# Staff Summary Report

**SUBJECT:** Hold a public meeting for a Development Plan Review for PRECISION DIE AND STAMPING located at 1744 West 10<sup>th</sup> Street.

**DPR08115** - Development Plan Review including site plan, building elevations and landscape plan for a building addition.

**PRECISION DIE AND STAMPING**

**FLOOR PLAN**  
1/8" = 1'-0"

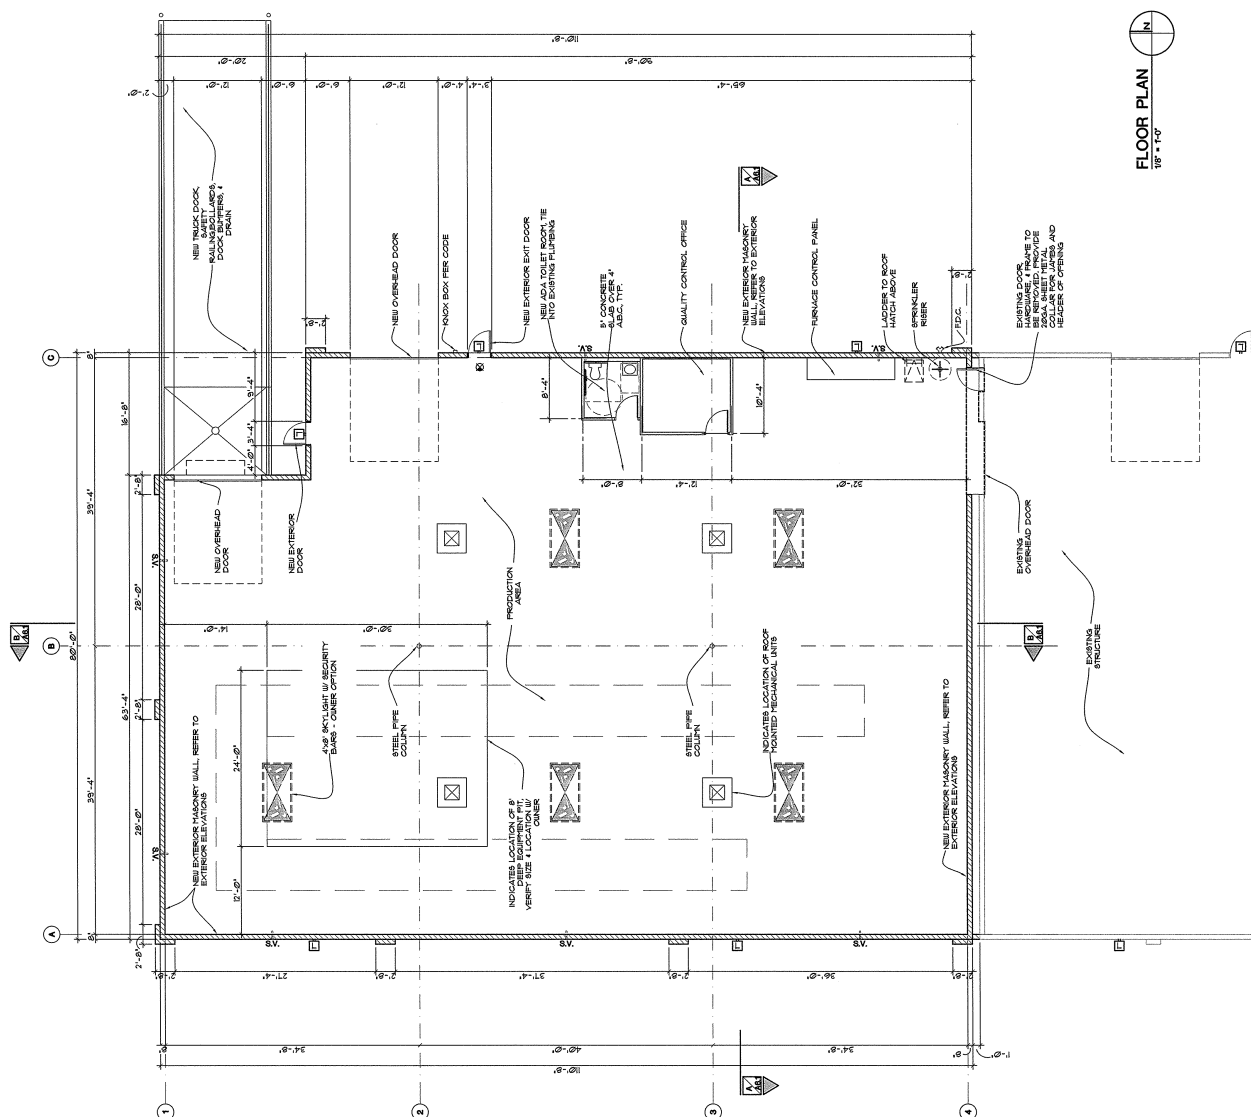
4. Restroom Security:
  - a. Lights in restrooms:
    - 1) Provide 50% night lights
    - 2) Activate by key or remote control mechanism
  - b. Single user restroom door hardware: Provide a key bypass on the exterior side

## EXTERIOR ELEVATIONS

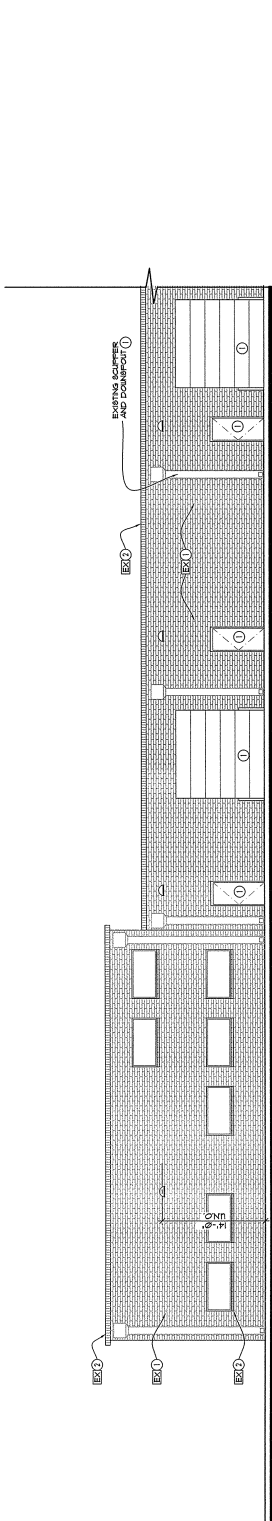
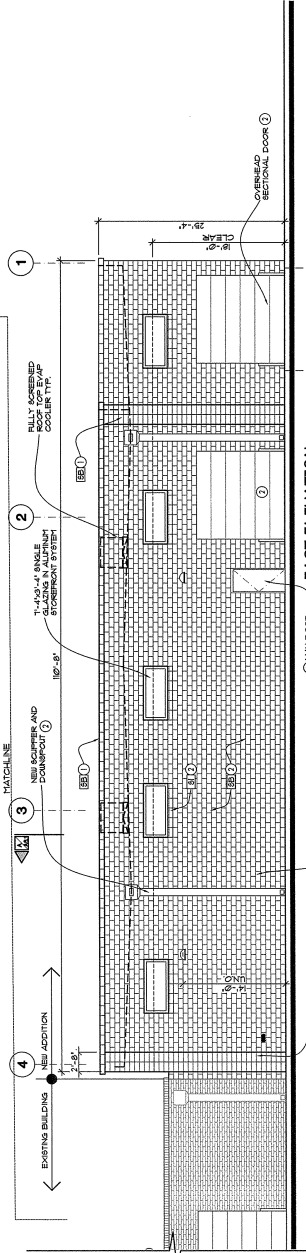
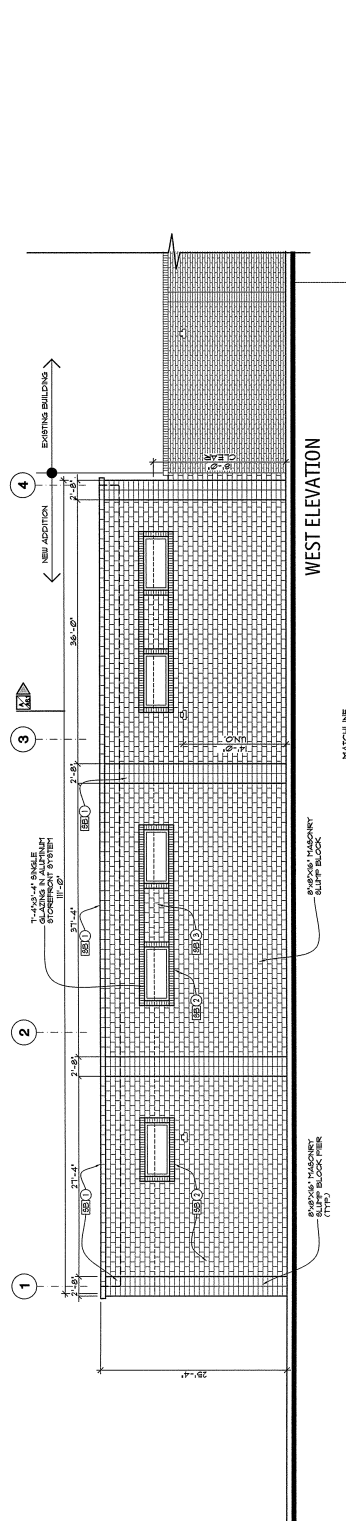
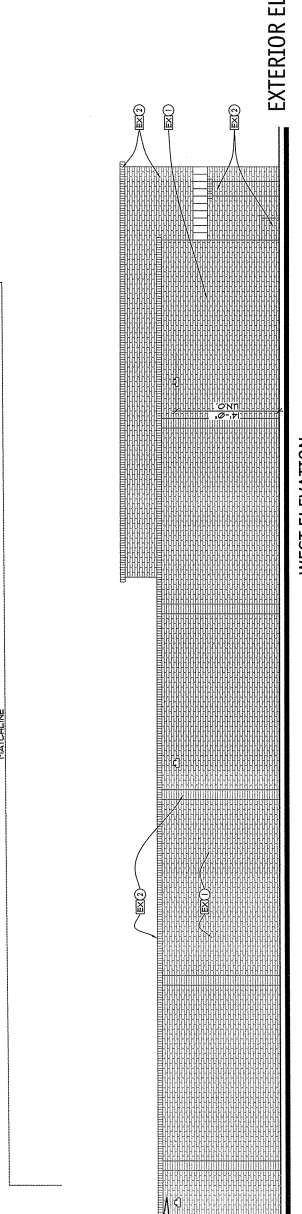
5. The materials and colors presented are approved as presented:  
Primary building – 8" Slump Block; Primary Color: DE6368 "Walrus", Accent Color: DE6366 "Silver Spoon"  
Accent mullions – Dark Bronze Anodized  
Glazing – Reflective Bronze  
Specific colors and materials exhibited on sample board are approved by planning staff. Submit any additions or modifications for review during building plan check process. Planning inspection staff verifies colors and materials during the construction phase.

6. Provide secure roof access from the interior of the building. Do not expose roof access to public view.
7. Incorporate lighting, address signs, incidental equipment attachments (alarm klaxons, security cameras, etc.) where exposed into the design of the building elevations.

8. Locate the electrical service entrance section (S.E.S.) inside the building or inside a secure yard, concealed from public view.
9. Exposed conduit, piping, etc. is not allowed.
